FMTV...

FAN SHROUD DIFFERENCES

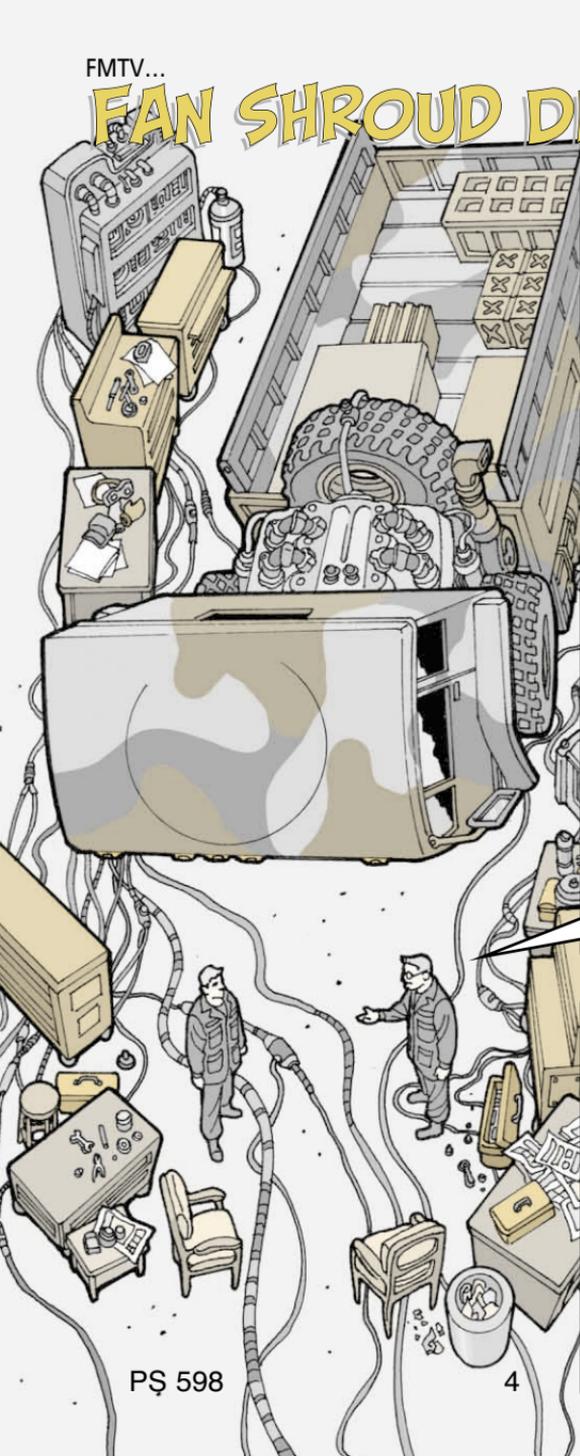
THE ORIGINAL TWO-PIECE FAN SHROUD USED ON FMTVs IS NO LONGER AVAILABLE. WHEN YOU HAVE TO REPLACE EITHER THE UPPER OR LOWER PIECE OF THE ORIGINAL SHROUD, YOU MUST ORDER **BOTH** PIECES OF THE NEW SHROUD.

IDENTIFY WHICH SHROUD YOUR TRUCK HAS BY LOOKING AT THE AREA WHERE THE PIECES ARE BOLTED TOGETHER. IF THE AREA IS **PARALLEL** TO THE GROUND (STRAIGHT), YOUR TRUCK HAS THE ORIGINAL SHROUD

IF THE AREA IS **ANGLED** (ABOUT 45°), YOUR TRUCK HAS THE NEW SHROUD. NEED A REPLACEMENT PIECE OF THE NEW SHROUD? ORDER THE UPPER OR LOWER SECTIONS AS NOTED.

THE NEW **UPPER** SHROUD COMES WITH NSN 2930-01-434-5219 AND THE NEW **LOWER** SHROUD COMES WITH NSN 2930-01-434-5220.
